CHANGE SUMMARY - MULTIPOSITION MICROELECTRIC ACTUATOR CONTROLLER

Technical Note 434

Figure 1: Visual and dimensional differences between the original controller (left) and the replacement controller (right)

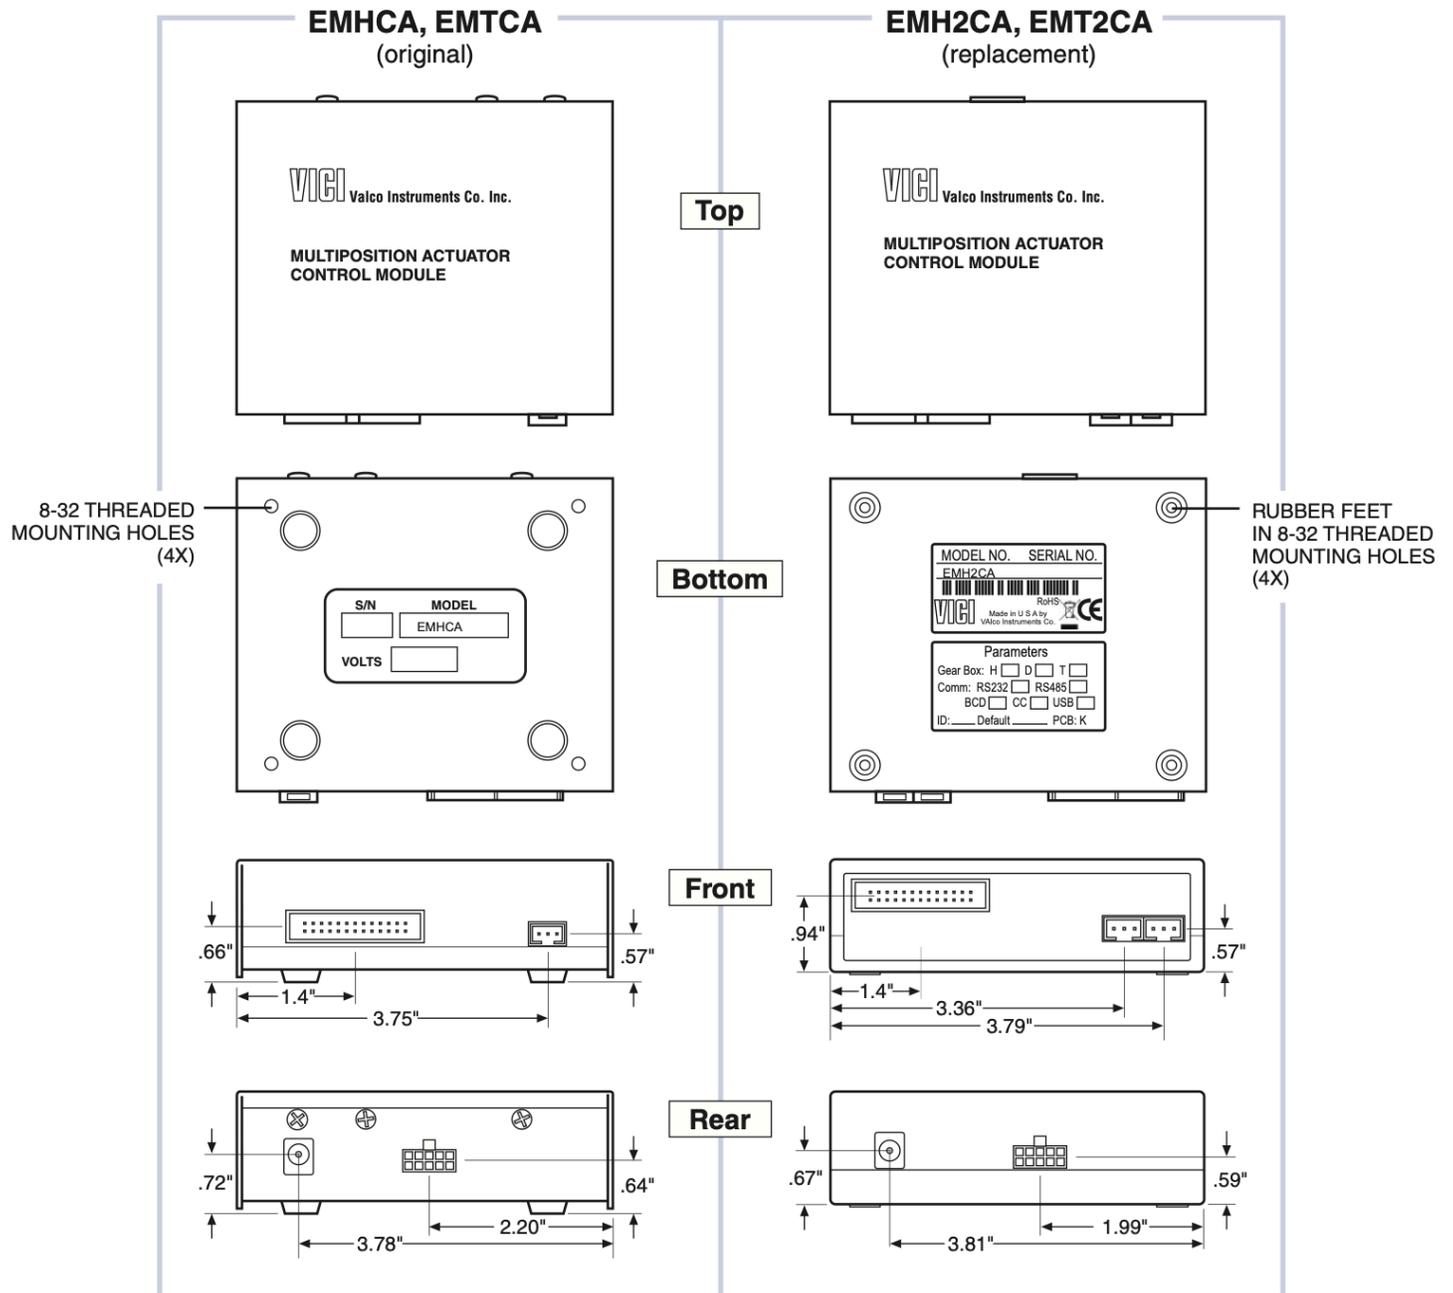
The circuit board had to be redesigned as several electrical components of the original controller were obsoleted by the suppliers.

- The replacement controller is identical in function and is backwards-compatible.
- The exterior dimensions and mounting hole locations do not change.
- Power and communications ports are in nearly identical locations, but have moved a fraction of an inch.

Please refer to **Figure 1** to compare the dimensions and appearances of the two controllers.

The part number for the controller will change from EMHCA and EMTCA to EMH2CA and EMT2CA. Part numbers for the full actuator assembly and valve/actuator assemblies will not change. It is understood that all actuator and valve/actuator assemblies shipped after the cut-over date will incorporate the replacement controller.
